| PROJECT | Smithsonian Institution- Revitalization of the Historic Core (RoHC) | MEETING DATE | 6/28/2023 |
| SUBJECT | Consulting Parties Meeting #14 | | |

MEETING MINUTES

Final landscape planting plan. Trees are placed around the Castle perimeter, with shrubs, perennials, and turf comprising the ground cover.

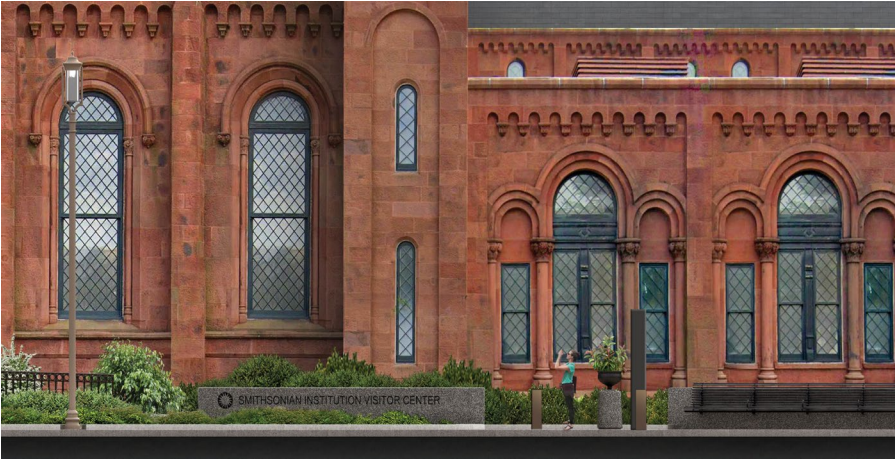
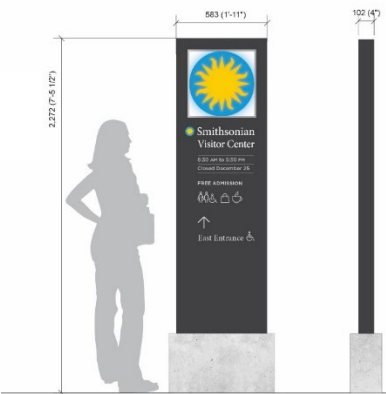
1. **Q:** Can you flip back and forth from existing/proposed planting plan? (CFA)

- Q:** Thank you for all of this information. There's a lot as usual, but it's really thoughtful. I asked you to go back and forth because when I was looking at the proposed it seemed to me that this is being called informal in the same way that the existing is, but to me there's a kind of formality to it. In the proposed plan it seems like there are these larger canopy trees that kind of set this fairly symmetrical framework. You have the two magnolias at the entrance, and at either wing there are these other two big specimen trees and smaller trees and shrubs underneath. I'm just curious do you think it will still have this informal appearance or a more formal appearance? Because of those larger trees being so symmetrically arranged it may have a more formal appearance with this 'stuff' below it that appears more informal. It seems more formal and symmetrical with how it's arranged, even the three trees on either side of the north entrance that are in triangular clumps.

Q (continued): It may be a matter of seeing it rendered. Something like different color berries may not bring that, but different shapes and different canopy forms will maybe bring that informality out. Did you use the term "treeless diversity"?

R: Here's our existing planting plan today, and our proposed.

R: I think one thing we're not really seeing in this image is the different kinds of trees and the feel and differences of them. Yes, the two flanking the south entrance are more formal in their placement. For the other two are deciduous trees, we were looking for a space related to the architecture of the building, so that guided the placement of those. There are also three different types of hollies, with two different color berries. There is a looseness to them especially when looking at the Haupt Garden, where there is more of an allee, and more consistent spacing and order. We understand the question but there is probably more looseness to them than conveyed in this specific diagram.

R: No, "tree list diversity"- different types of trees out there. It would be helpful to have a couple of rendered views of the planting plan. We'll take a look at that. (follow up for CP15)
